STAFF RECOMMENDATION

420 North 16th Street

August 16, 2017

Application: New construction – infill with setback determination

SITE PLAN

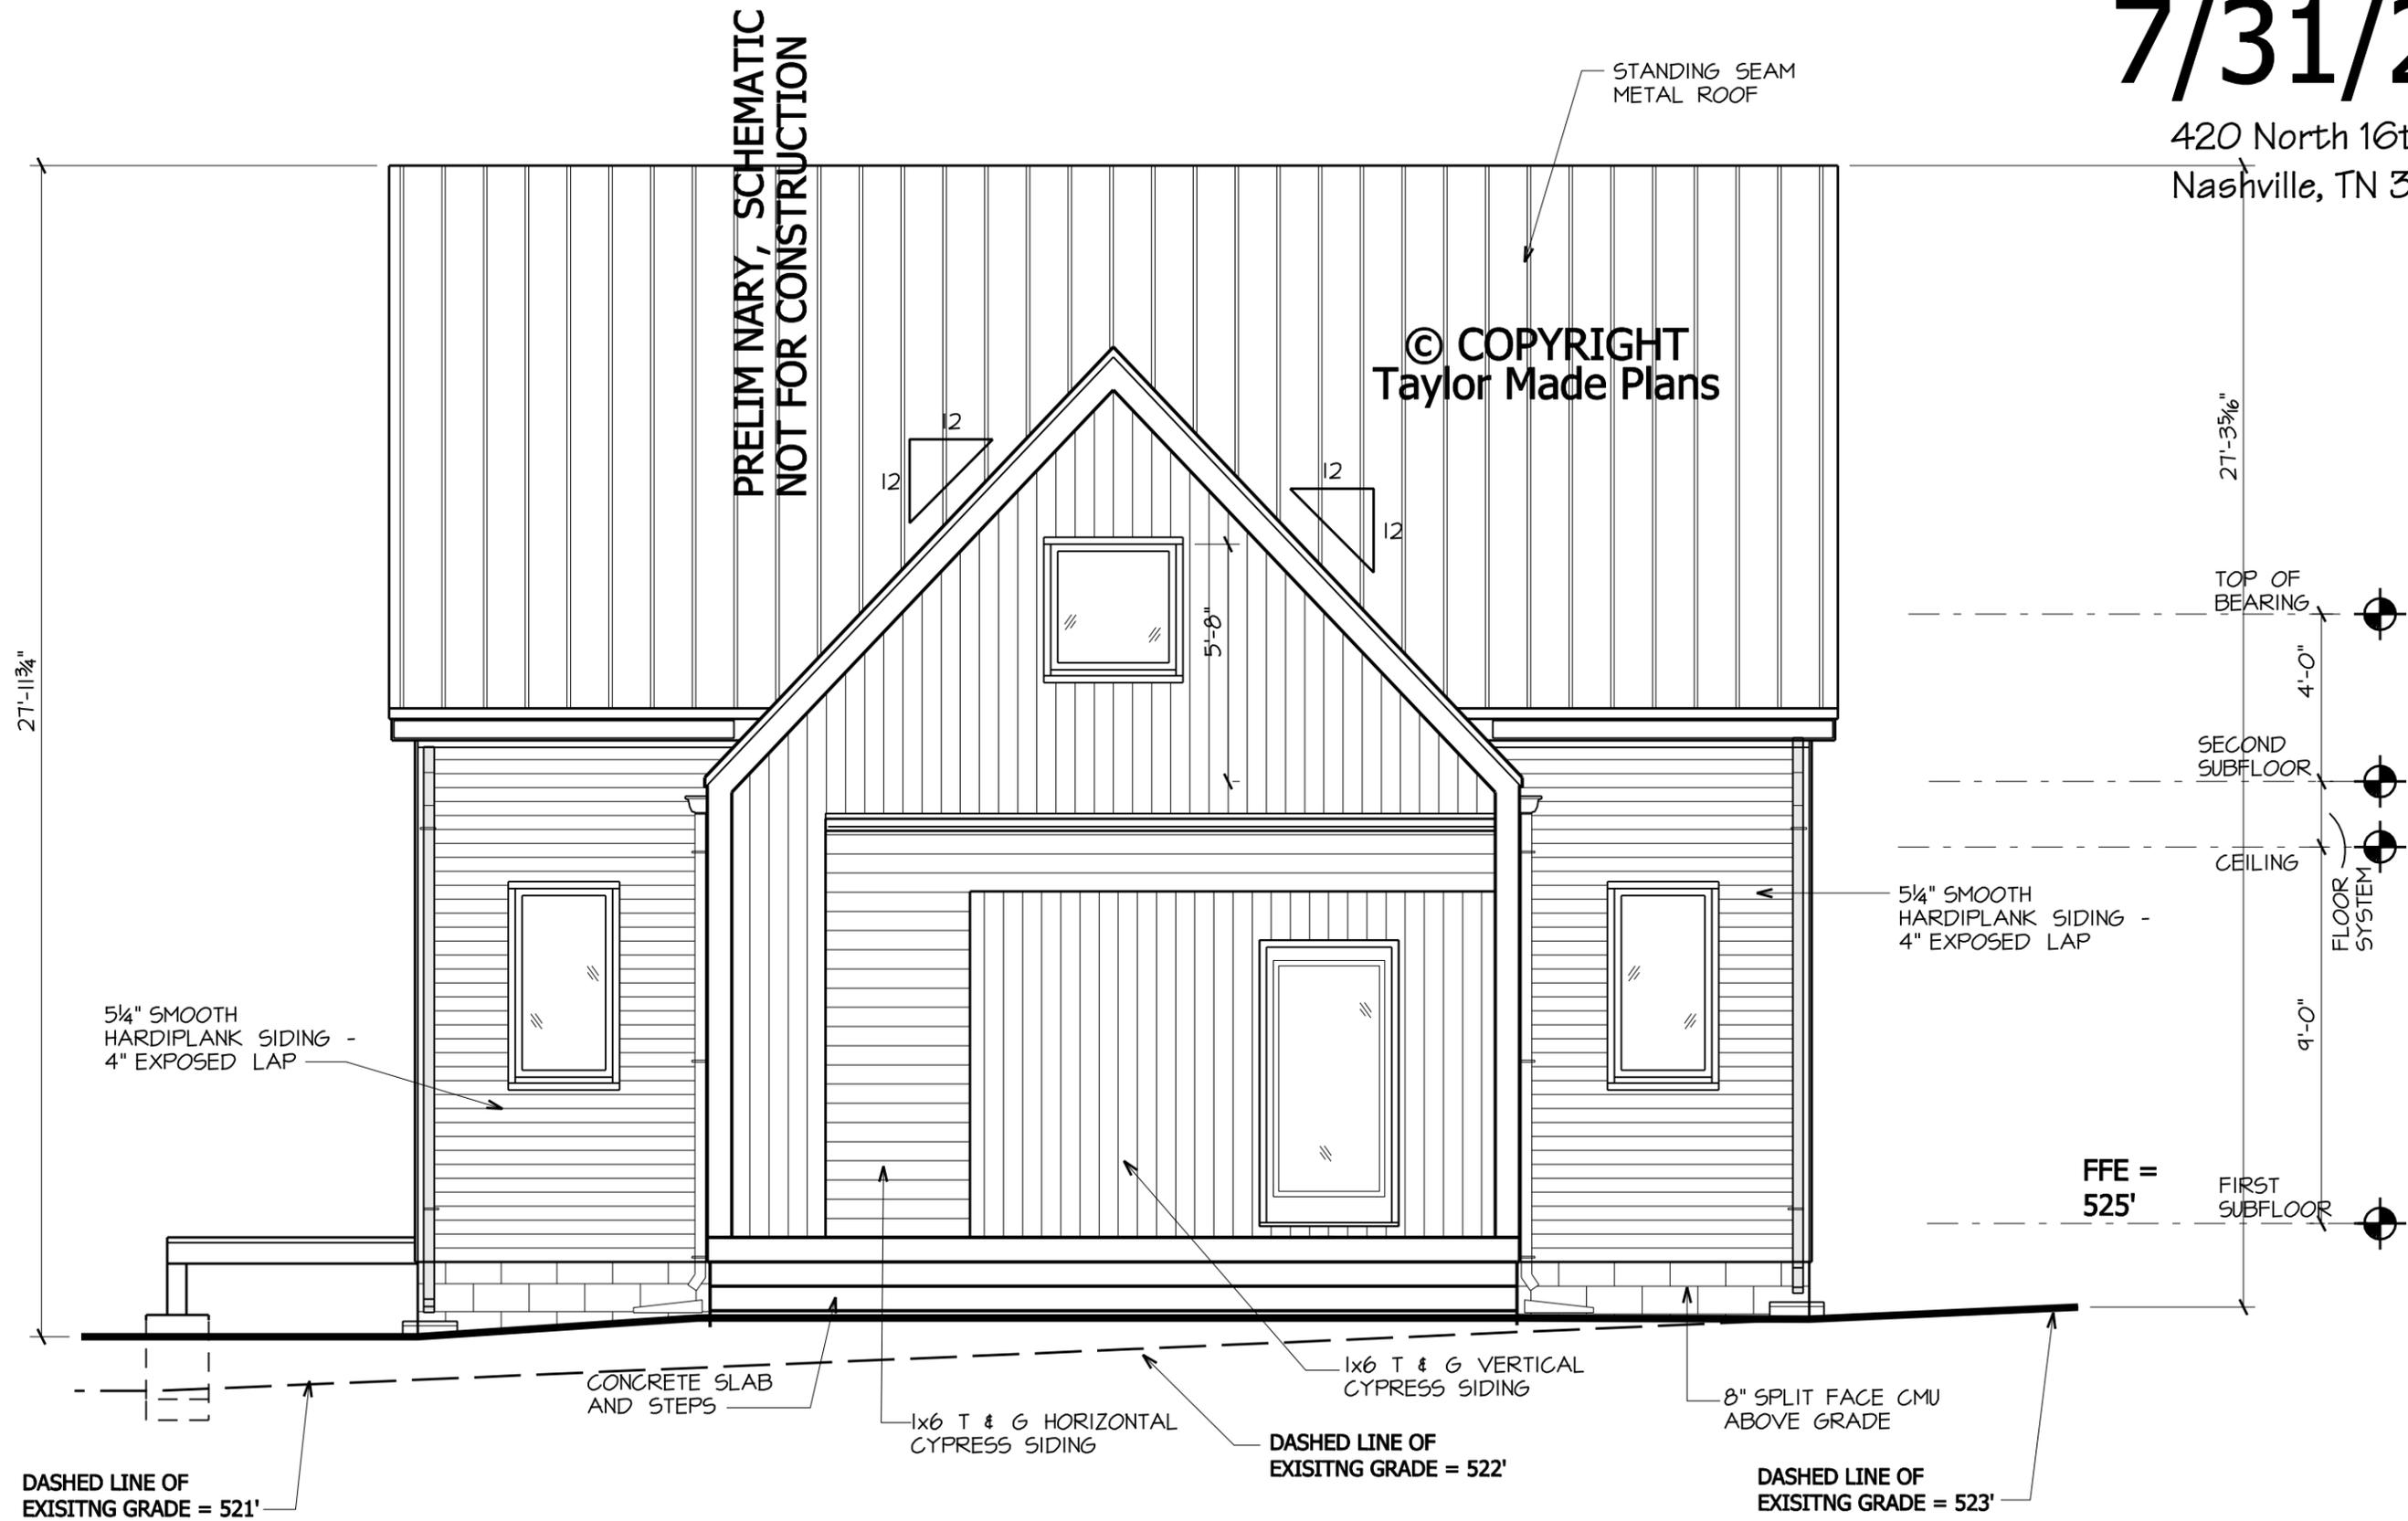
Appurtenances & Utilities: The location of the HVAC is shown to be on the left side of the house beyond the midpoint. A walkway will connect from the front porch to the sidewalk at the front of the lot. An existing driveway which begins on the neighboring property currently cuts into this rear yard will be retained, with modifications indicated behind the house. Additional information on the modifications is needed. With a condition that the driveway modifications are approved administratively, Staff finds that the proposal will meet section II.B.9 of the design guidelines.

FRONT ELEVATION

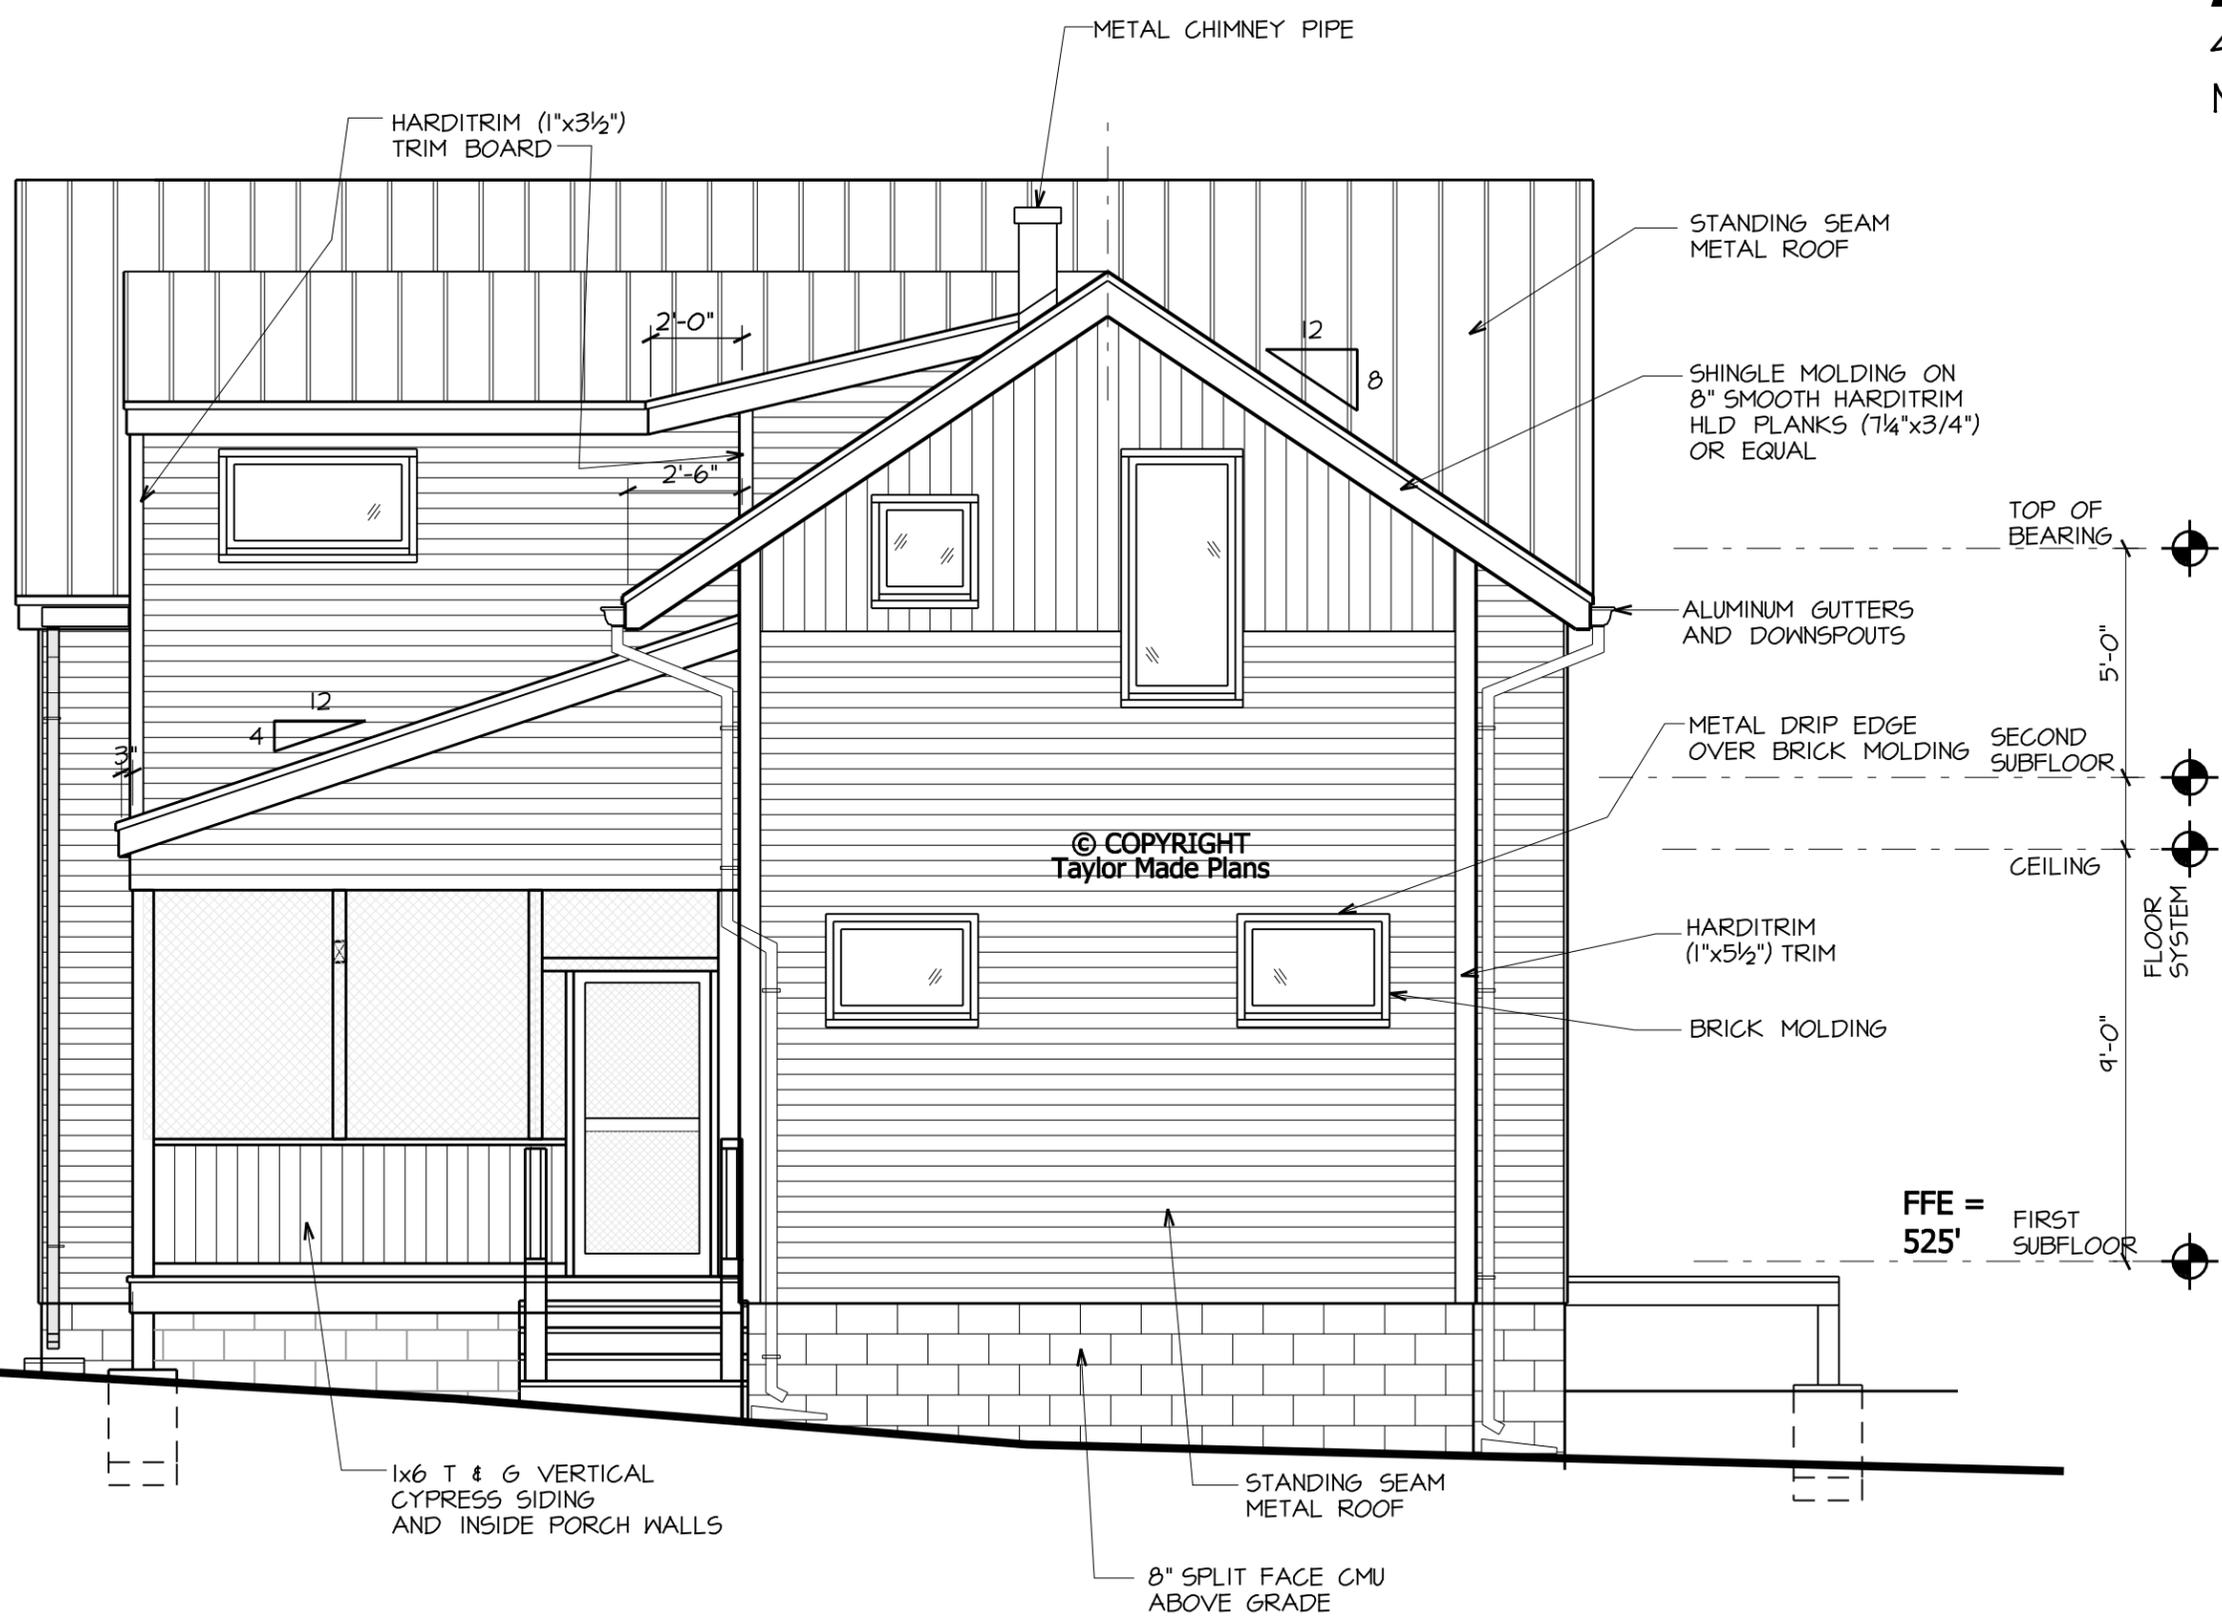
The primary exterior material on the first story of the one and one-half story house will be cement-fiber clapboard with a four inch (4') reveal, and the upperstory walls will be clad with six inch (6") flush vertical wood siding. The primary material is common throughout the neighborhood. Vertical siding is less common, but it was also used historically; therefore, Staff finds it to be appropriate as a secondary cladding material. While the materials are appropriate, the transition from primary to secondary cladding occurs five feet, six inches (5'-6") above the first story window heads at the point where the front roof slope bears on the top of a four foot (4') upperstory knee-wall. Historically material changes typically happen at a floor level and in many cases there is a trim band or belt-course used to distinguish and address material changes. The material change on the proposal is abrupt and is significantly higher than is typical of most historic houses, giving the house the appearance on an unusually tall first story.

These roof forms and pitches are all common in and of themselves, however it is not typical to have a building where every slope of the roof is a different pitch, especially on such a small form and a building with a simple, clean design. Staff finds that the effect of having multiple pitches together is a roof that is not compatible with the character and roofs shape of surrounding historic houses.

Rhythm and Proportion of Openings: The windows on the first story walls of the house will be generally twice as tall as they are wide, with the majority of first story windows taller than those on the upperstory, as is typical historically. Because the siding materials change so high on the side facades, however, the wall proportions read taller than is typical of a one and one-half story house leaving the first story windows appearing unusually short. Another effect of the high siding transition is that the second story window sills sit below the material change, giving them somewhat the appearance of straddling the first and second stories. How these window proportions are perceived may be improved by a revision to the siding, but it may also be necessary for the window locations and proportions to be revised to have proportions more appropriate for the first and second story wallspaces in order to meet section II.B.7 of the design guidelines.

Orientation: The new structure will be aligned with the front elevation parallel to North 16th Street, with projecting porch element on the center of the front façade. This is compatible with the context of the street. The porch will be six feet, eight inches (6'-8") deep on the front. Whereas projecting porches typically read as open, the proposed porch will have side walls with punched openings and a partially-projecting wall cut into the porch area from the primary wall behind. These features constrict the porch in a way not typical of houses historically. Staff recommends that the side walls and projecting walls are removed so that the porch reads open. With that change, Staff finds that the orientation of the building will meet guideline II.B.6.

Staff recommends that the exterior cladding is revised so that the material change is more typical of one and one-half-story houses in the surrounding area. Additionally, Staff would recommend that the roof color and the final selections of windows and doors are approved administratively. With those conditions, Staff finds that the materials of the proposal would meet guideline II.B.4.

Staff recommends that the roofs of the building are revised to be more consistent, as is typical of surrounding historic buildings, in order to meet section II.B.5 of the design guidelines.

FRONT ELEVATION

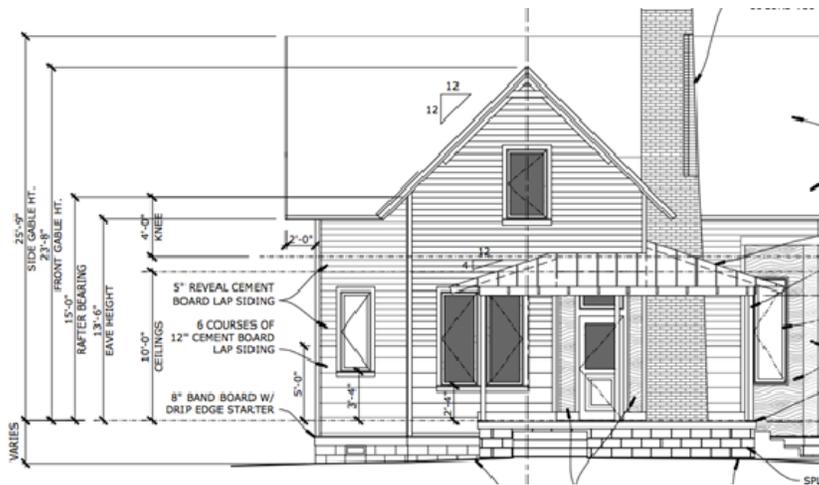
- 4' knee wall indicated
- Described as 1.5 story by staff
- Similar, if not identical, eave height specified
- Similar overall height from finished floor
- Recommended approval by staff
- Awarded Infill Award

- Modern design - Mixed material use

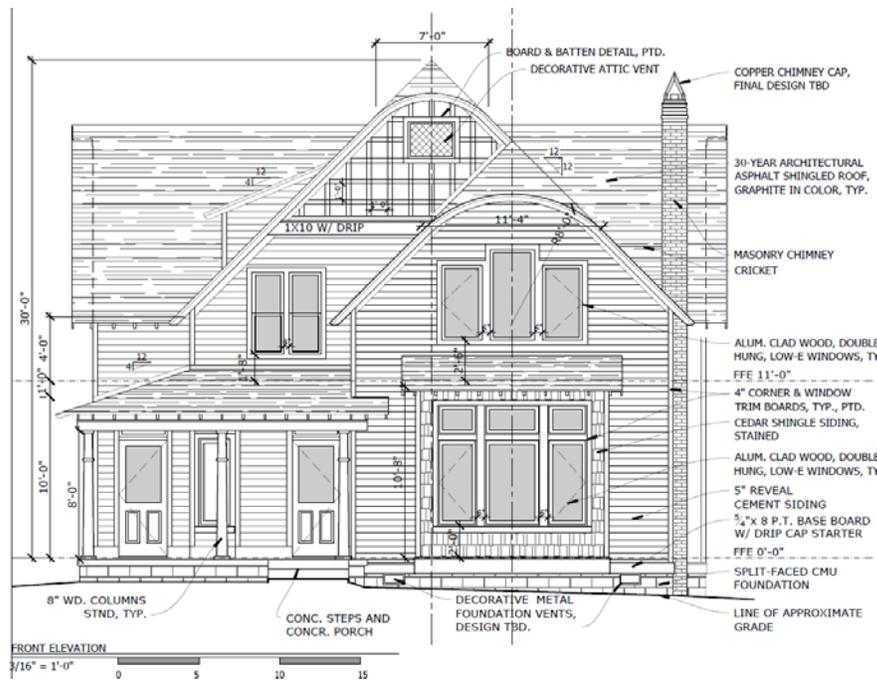
4' knee wall indicated
